DEVIATION REQUEST AND DECISION FORM

Project Name : Eagle Forest Subdivision

Deviation #1: A deviation from the standards of or in Sections 2.3.8.A of the Engineering Criteria Manual (ECM) is requested. The request is to allow a proposed non-through road, Eagle Forest Drive, with a length of 2,542 feet. Please refer to Deviation Exhibit 1.

Exhibit 1

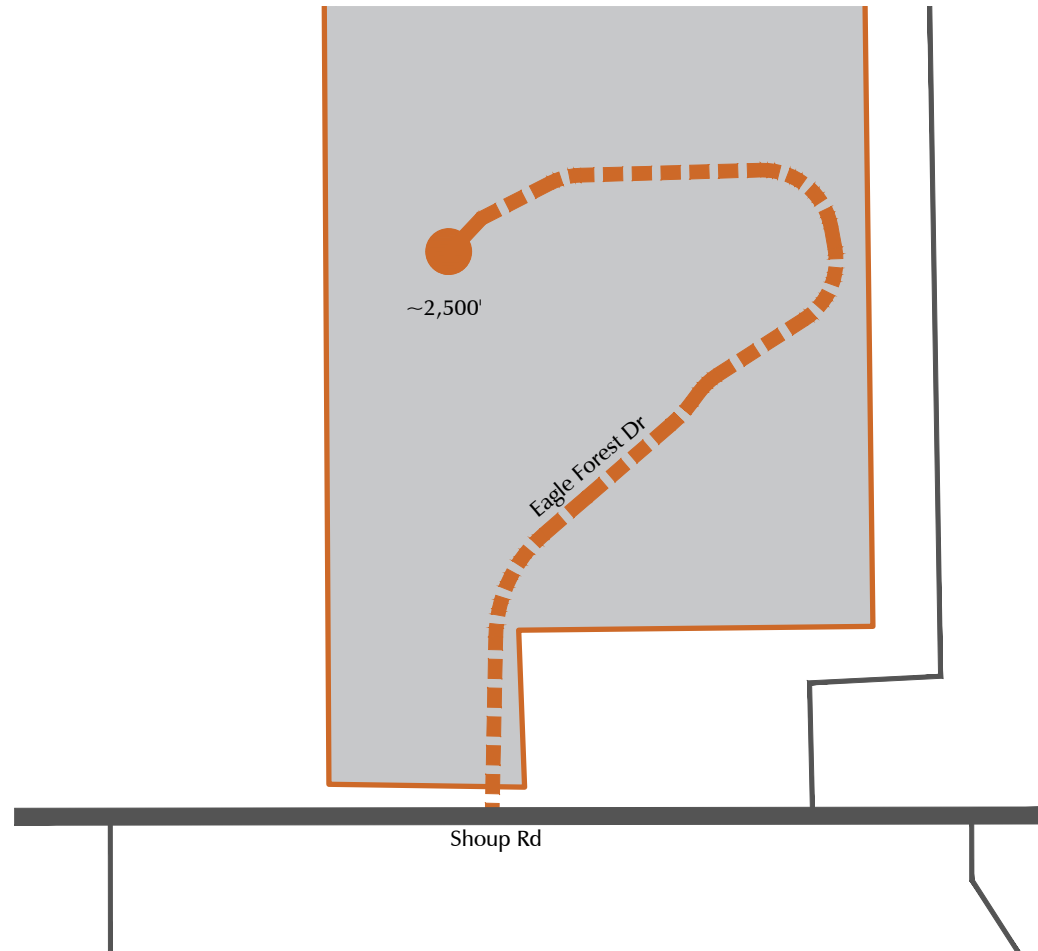
Cul-de-sacs shall have a maximum length of 1,600 feet for rural condition. The request is to allow a non-through street, Eagle Forest Drive, with a length of approximately 2,500 feet. Please refer to Deviation Exhibit 1.

- The cul-de-sac termination on the east access (located 2,542 feet from Shoup Road) would exceed the ECM standard of 1,600 feet by 942 feet.
- The proposed cul-de-sac is shown in the attached exhibit Figure 2 (site plan).

Black Forest Fire Rescue approves the current submitted preliminary plans for the Eagle Forest Subdivision plat with the 30,000-gal cistern and turnout, with the second turnout we discussed on the phone located on the north end of the road with the same 10x30 ft dimensions indicated within the final plat submission. The second turnout will meet current code NFPA 1141 sec 5.2.17.3. and must follow current Land Development Code requirements. Black Forest Fire Rescue understands that the developer has agreed to construct the second turnout and we agree to them adding the second turnout to the project plans at the Final Plat stage.
